RESOLUTION NO. 2207

A RESOLUTION OF THE CITY COUNCIL OF THE CITY OF KIRKLAND AMENDING SECTION 3 OF RESOLUTION NO. 2202 WHICH APPROVED THE PRELIMINARY APPLICATION OF A PLANNED UNIT DEVELOPMENT TO BE KNOWN AS YARROW BAY OFFICE COMPLEX BEING DEPARTMENT OF COMMUNITY DEVELOPMENT FILE NO. PUD-73-32(H) AND PROVIDING THAT CONSTRUCTION OF AN AUTOMOBILE AND PEDESTRIAN BRIDGE ACROSS THE REALIGNMENT OF YARROW CREEK SHALL BE WITHIN THE AUTHORIZED SITE PREPARATION WORK AND CREEK BED REALIGNMENT.

AMENDED
ADMINISTRATIVE REPORT

AMENDED 9/14/73
ADMINISTRATIVE REPORT:
LAKE VISTA TERRACE DIV. NO. 2

LAKE VISTA TERRACE DIVISION NO. 2

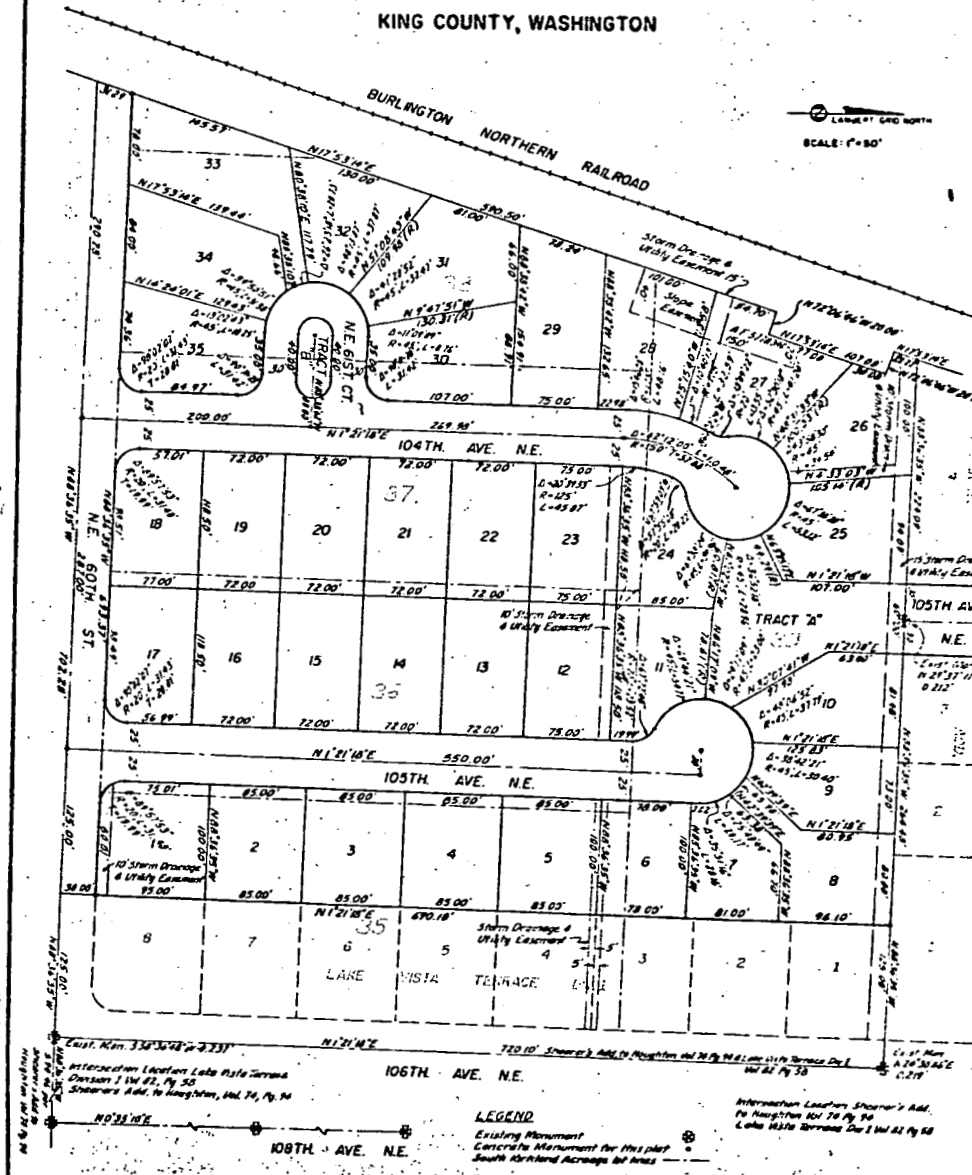
3. A storm drainage holding basin not be required between Lots 27 and 29.
4. That the 3.58 open space be required to be located between Lots 10, 11, 24 and 25 and the following improvements to be made:

- a. A 10 foot paved walkway is to be constructed connecting 105th Ave. N.E. to the north with 104th Ave. and 106th Ave. to the south.
 - b. A 3'6" cedar fence, as submitted by the applicant to the City, is to be installed adjacent to Lots 10, 11, 24 and 25.

- c. The area is to be graded and seeded.
 - d. That this open space, referred to as Tract A, be deeded to the City of Kirkland with costs of future improvements and/or maintenance to be borne by all lot owners within the plat.

5. Tract B, the island in the small cul-de-sac on 104th Ave. N.E., is to be deeded to the City with the costs of future improvements and/or maintenance to be borne by the owners of Lots 30, 31, 32, 33, 34 and 35.

6. That a variance be granted to allow a 20 foot frontage for access to Lots 8 and 33

- The Houghton Community Council and Planning Commission hereby adopt the above conditions and recommend approval of the Final Plat of Lake Vista Terrace Division No. 2 subject further to the following conditions.
 - That a barricade be installed along the entire northern portion of Tract A to the satisfaction of the Park Director which would allow only pedestrians to pass through, and not cars or motorcycles.
 - That prior to the filing of the Final Plat, a bond shall be deposited with the City of Kirkland to cover the cost of all public improvements not completed, and the bond size to be determined by the Public Service Director.
- A copy of the revised Final Plat drawings are hereby attached to this report and approved subject to the conditions and stipulations contained herein.
